City of Seattle ANNOTATED VERSION (September 5, 2008)
Stormwater Code and Manual 2-2008 Submittal for Ecology Review
Observations and Questions
April 7, 2008

Note: This document provides feedback to various questions, issues, and comments to the Washington State Department of Ecology (Ecology) regarding that agency's review of the from the City of Seattle's proposed Stormwater Code, associated technical criteria contained in the City's Directors' Rules, and supporting documentation, all of which were provided by Seattle to Ecology on February 15, 2008, pursuant to the City's NPDES Municipal Stormwater Discharge Permit. For clarity, Ecology's comments are indicated in Times New Roman font (black) and the City's comments are indicated in Arial font (teal).

Note that the version of the draft Seattle Municipal Code (SMC) 22.800-22.808 Stormwater Code accompanying this document is also dated September 5, 2008.

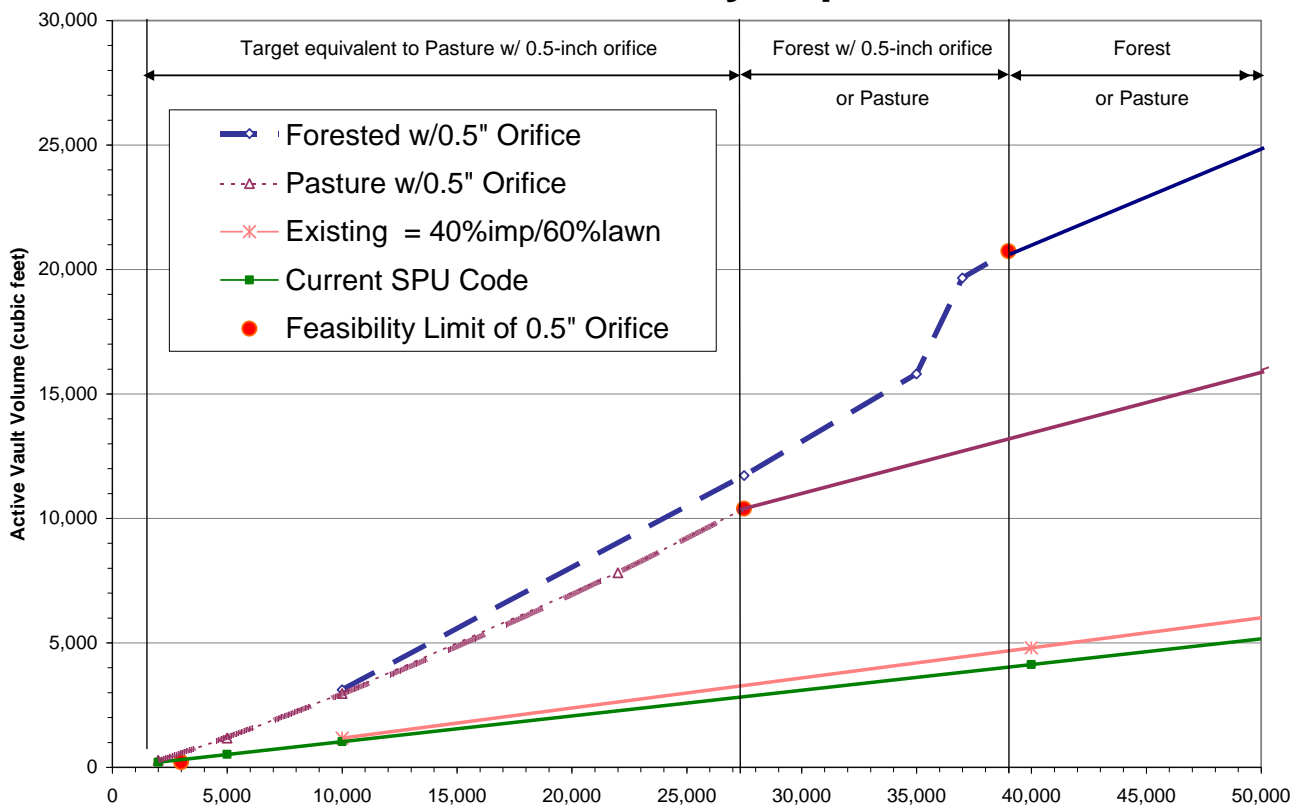
The Seattle proposal as a whole is not acceptable (see bullets below). There are elements of it that are acceptable depending upon % TIA of the basin and whether the project is new development or redevelopment. Because Seattle does not want to distinguish between new and redevelopment, potential solutions are more difficult to identify. Appendix 1 does not provide for deviations where new development projects exceed the thresholds; Appendix 1 does provide for deviations from the standard redevelopment requirement where there is a commensurate or greater benefit with another approach.

- For basins with less than 40% TIA:
 - New development projects with $\geq 10,000$ sq. ft. effective impervious in a TDA must use the Ecology standard (forested; $\frac{1}{2}$ the 2-year through the 50-year).

We can rewrite Seattle's minimum requirements such that the post-development performance standards is based on a pre-Columbian forested condition for all new development projects $\geq 10,000$ ft² for projects located in basins with less than 40% historic total impervious area (TIA). However, by extensive modeling we have determined that a forested standard cannot be achieved until the contributing impervious surface area is approximately 39,000 ft² owing to a minimum orifice size limitation of 0.5". Our own, proposed pasture condition cannot be fully achieved until there are approximately 27,500 ft² of effective impervious surface area discharging into the flow control facility (see the figure provided on the next page). Based on the assumptions used in our modeling, the active vault volumes for the two

performance standards are similar until approximately 27,500 ft² with a more pronounced divergence beginning to appear at approximately 35,000 ft² (see figure below).
